FORD AXOD

SOFT 1-2 SHIFT

Figure 1

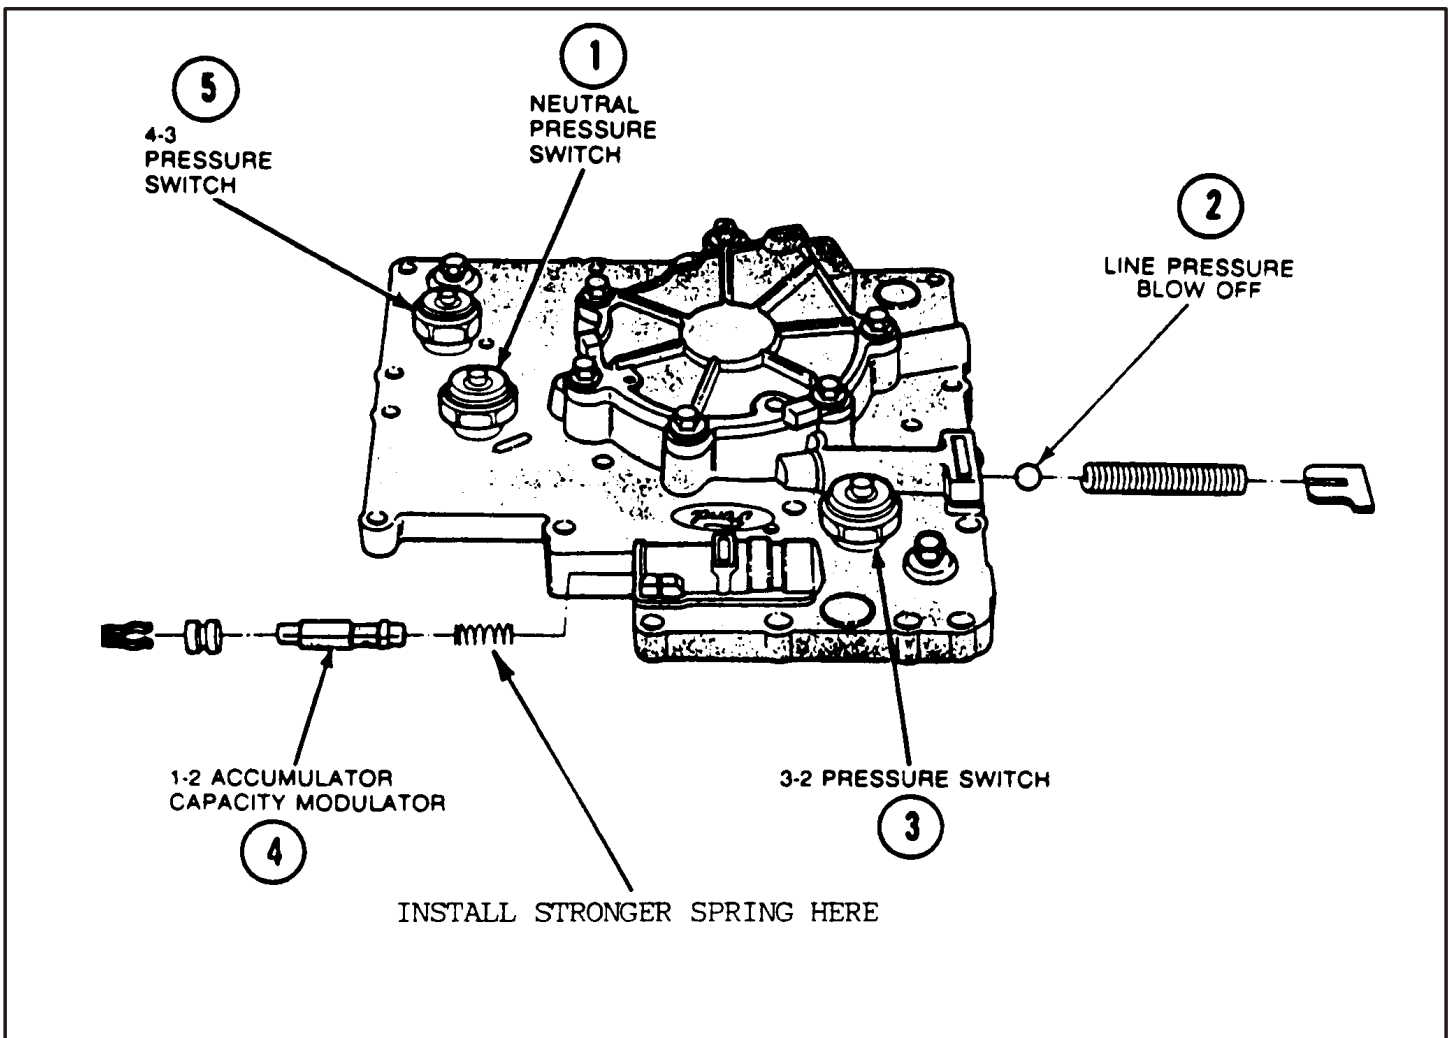
COMPLAINT: Soft or mushy 1-2 upshift only.

CAUSE: Fill time for intermediate clutch too slow.

CORRECTION: Install stronger spring on the 1-2 capacity modulator valve located in pump body (See Figure 1).
